DAGGETT COUNTY MUNICIPAL BUILDING AUTHORITY AGENDA
Tuesday, May 19, 2026 AT 9:30 A.M.
Daggett County Courthouse (95 North 1st West; Manila, UT 84046)
Public Access Is Available Through Electronic Means At
meet.google.com/ewi-tjgt-axg

Change Order

PROJECT: *(Name and address)*
Daggett County Health, Business and
Community Center
105 North 100 West
Manilla, Utah 84046

Proposal Request

A. X-Ray Room

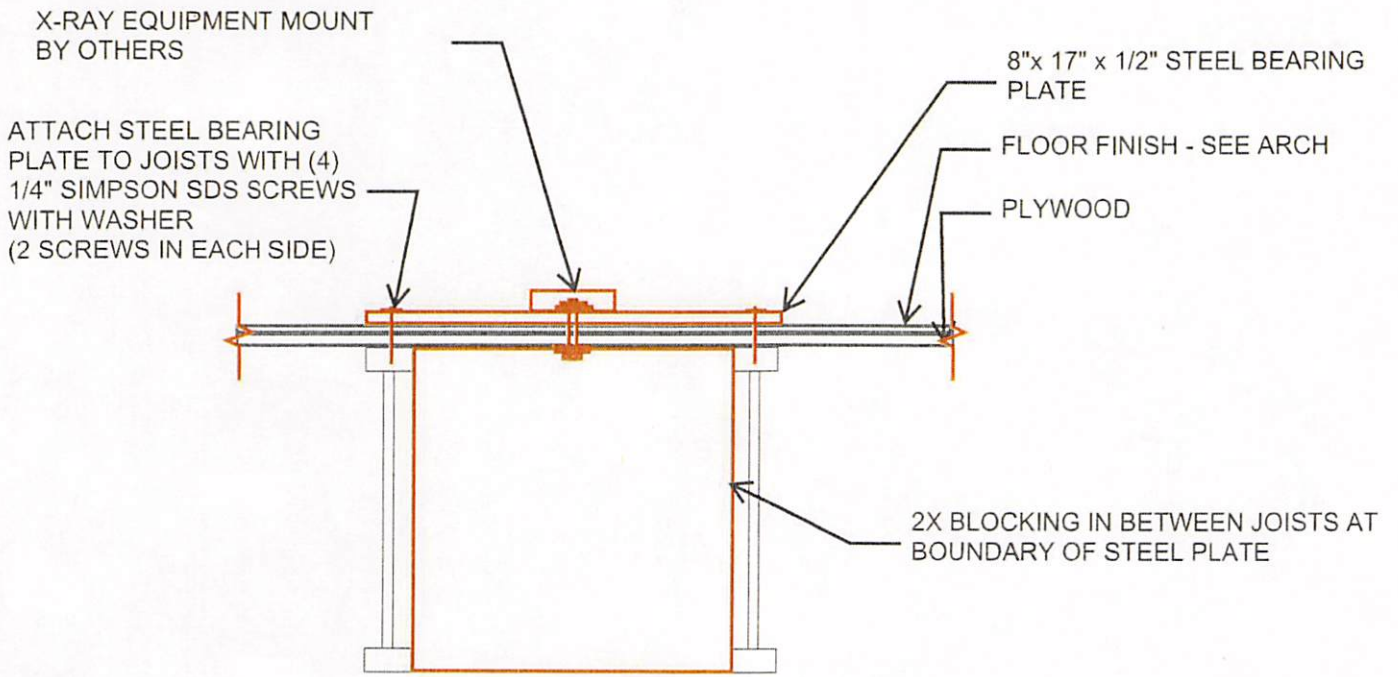
1. Wall for X-ray equipment to be added as shown on A-404
2. Wall adjacent to changing area to be cut back as dimensioned on A-404.
3. Shielded wall for x-ray staff to be pulled back as dimensioned on A-404

LOCATIONS OF STEEL BEARING PLATES

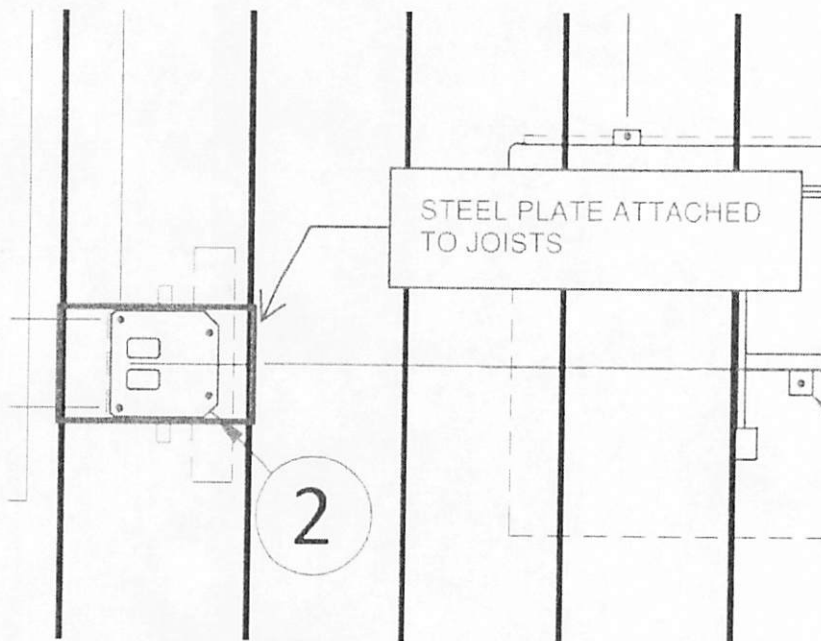
From these plans, it looks like the wallstand needs to be a minimum of 7.9 inches from the wall (sheet 10 of the x-ray equipment plans).

Based on those plans, the wallstand will need to be mounted to the floor. This should be done similarly to how the x-ray table will be mounted:

The X-ray wallstand will be anchored to 17" x 9" x ½" steel plates, spanning between two floor joists. The plate shall be secured to each floor joist with (2) ¼" SDS screws with washers on each side. The x-ray wallstand will then be fastened to the steel plate via through-bolts sized per the manufacturer's original mounting specifications. Solid 2x wood blocking shall be installed at the boundaries of each steel plate.
